ILLINOIS POWER COMPANY

Subject: Clinton Power Station
Inservice Testing Program

In response to the letter from J. A. Stevens to F. A. Spangenberg dated May 5, 1988, Attachment 1 responds to the questions on the Inservice Testing (IST) Program. Attachment 2 summarizes the other changes made to the IST program. Relief Requests are in Attachment 3, and Attachment 4 is Revision 5 to the Pump and Valve Testing Program Plan. If there are any questions on this submittal, please contact me.

RELIEF REQUEST NO. 2020 (Revision 1)

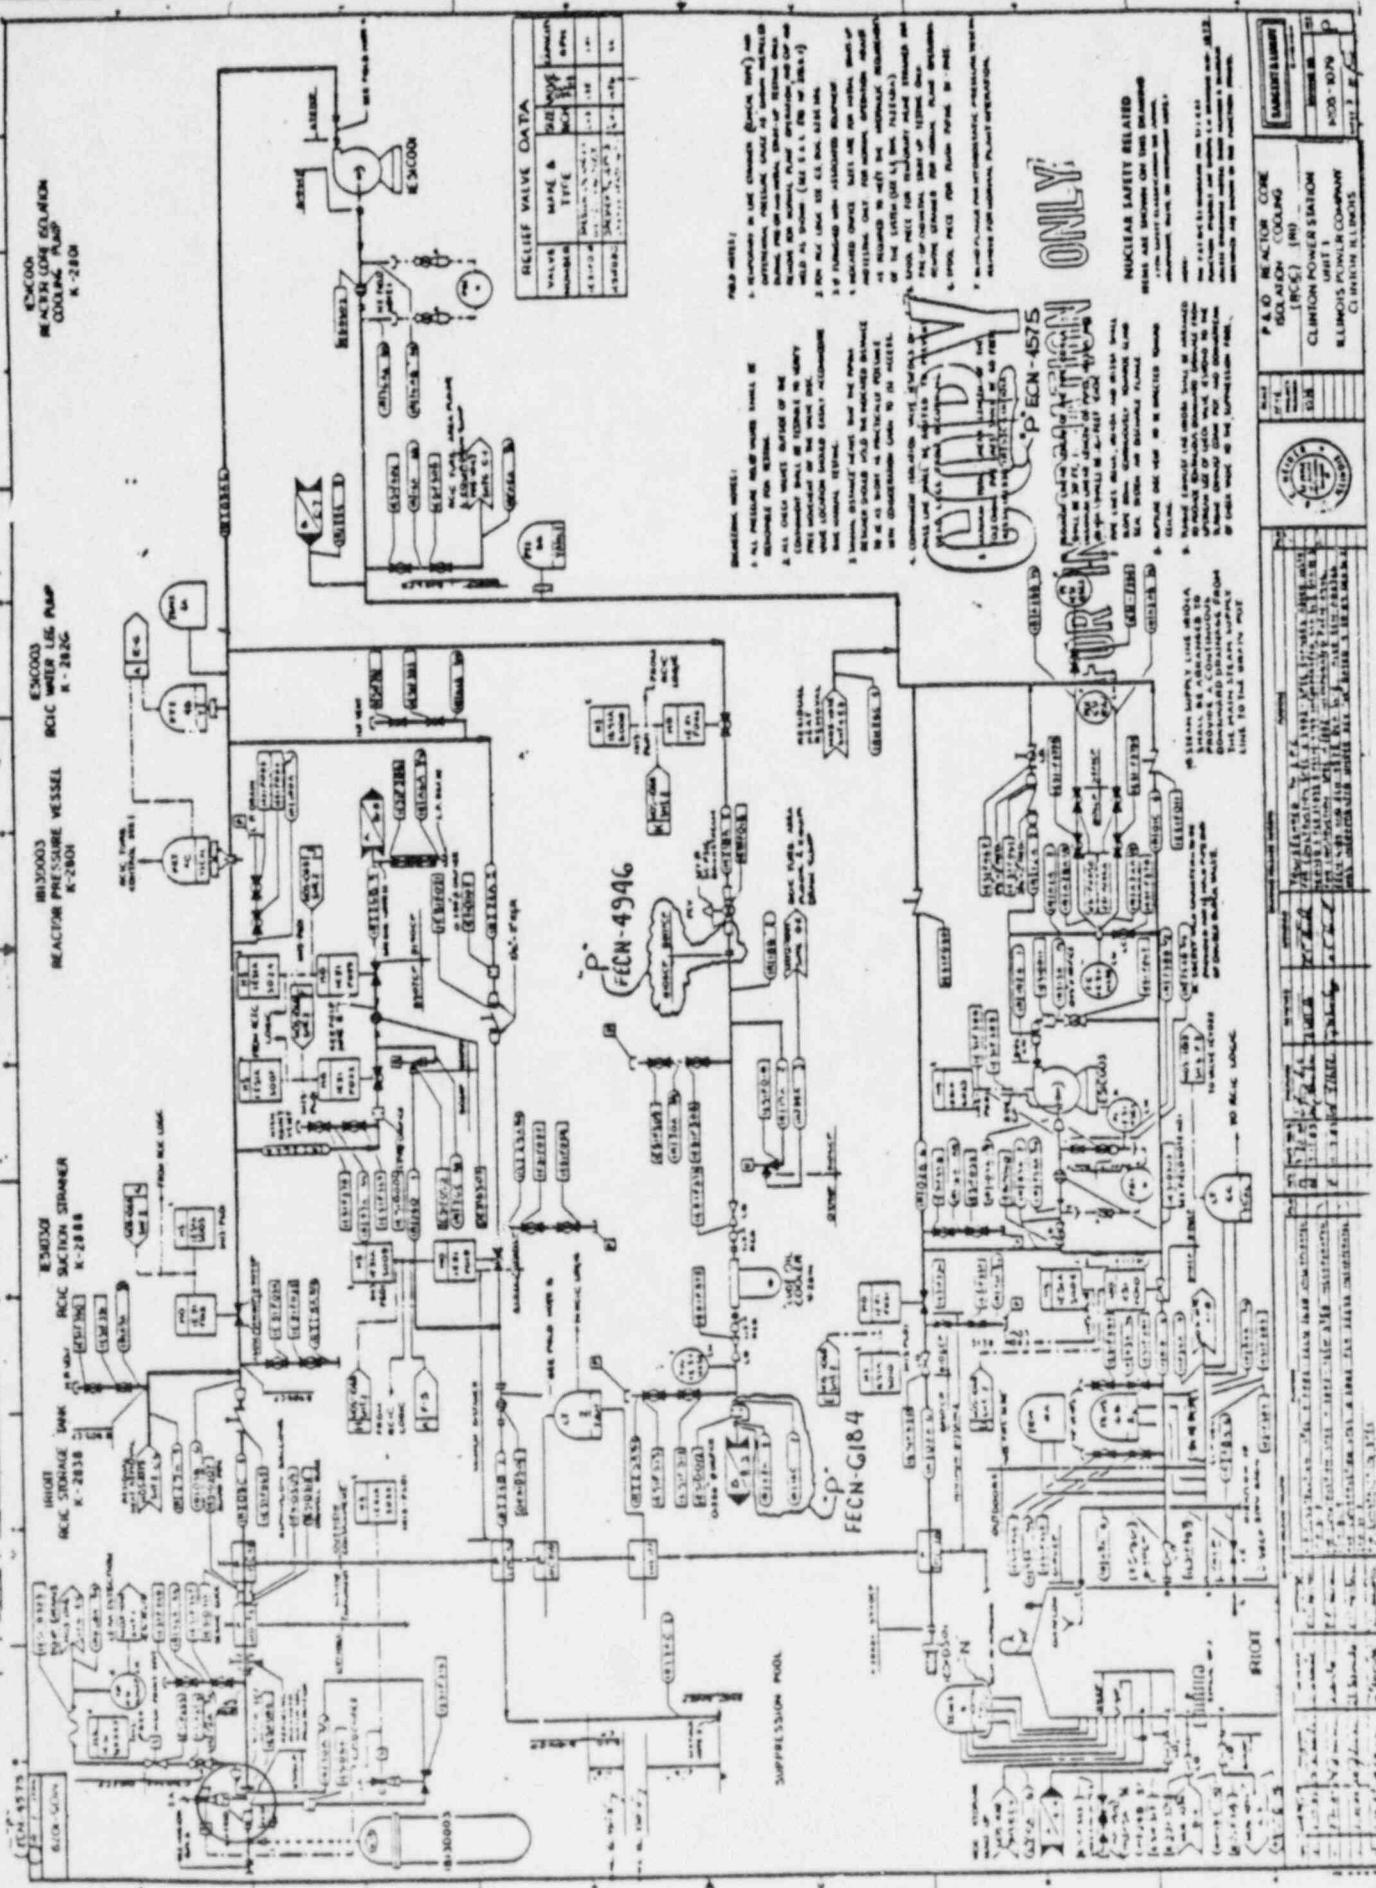
Testable check valve 1E51-F066 provides pressure isolation from the high pressure Reactor Coolant System and the low pressure Reactor Core Isolation Cooling (RCIC) system. It is an ASME Section III Code Class 1, Section XI Category A/C valve. It is a 4 inch non-slam check valve and is circled on the attached drawing.

The ASME Code Section XI, Subsection IWB-3520 requires that when check valves are exercised with flow, the flow measured shall be adequate to verify the function of the valve.

The design flow for this injection valve is 600 GPM. During the reactor shutdown cooling mode, the flow through this line is normally 400 GPM and is restricted to a maximum of 500 GPM. This restriction is in place to assure the cool down rate for the vessel is not exceeded. This difference in flow rates is not considered significant in determining valve operability.

This valve will be exercised utilizing the flow supplied by the Residual Heat Removal system during the reactor shutdown cooling mode. This flow is normally 400 GPM and is restricted to a maximum of 500 GPM.

RELIEF REQUEST NO. 2028

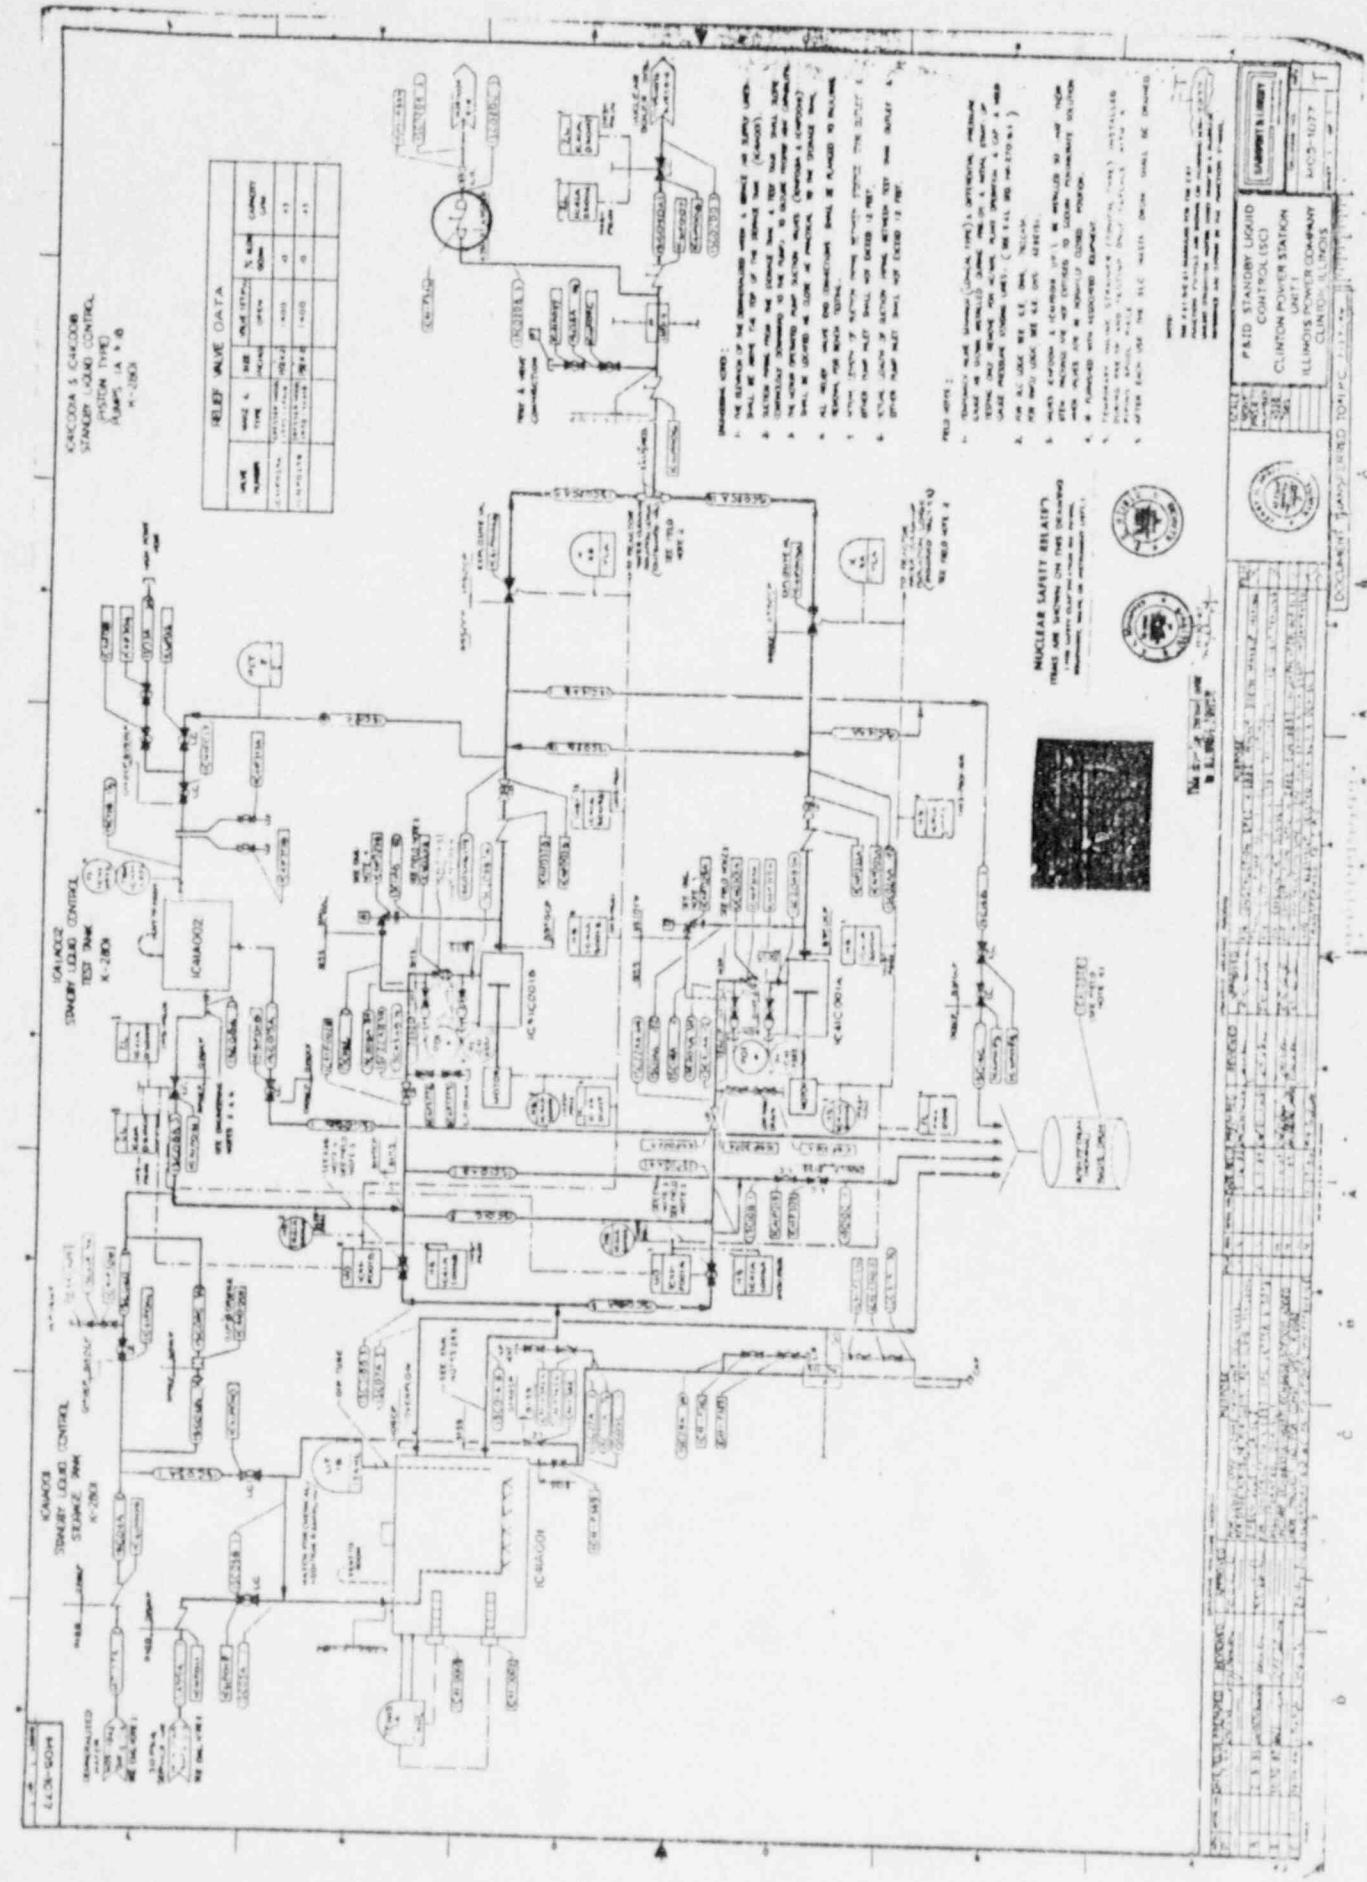
Valve LC41-F336 is a check valve downstream of the Standby Liquid Control (SC) pump and is physically located inside the drywell. This is an ASME Section III Class 1, Section XI Category A/C, 4" check valve. The valve is circled on the attached drawing.

The ASME Code, Section XI, Subarticle IWV-3521 requires that this check valve be exercised every three (3) months.

This check valve is downstream of the explosive injection valves which are only required to be opened during refueling outages.

The check valve is totally enclosed without any provisions for exercising the valve externally.

Illinois Power Company will full stroke exercise this check valve every refueling outage with system flow.
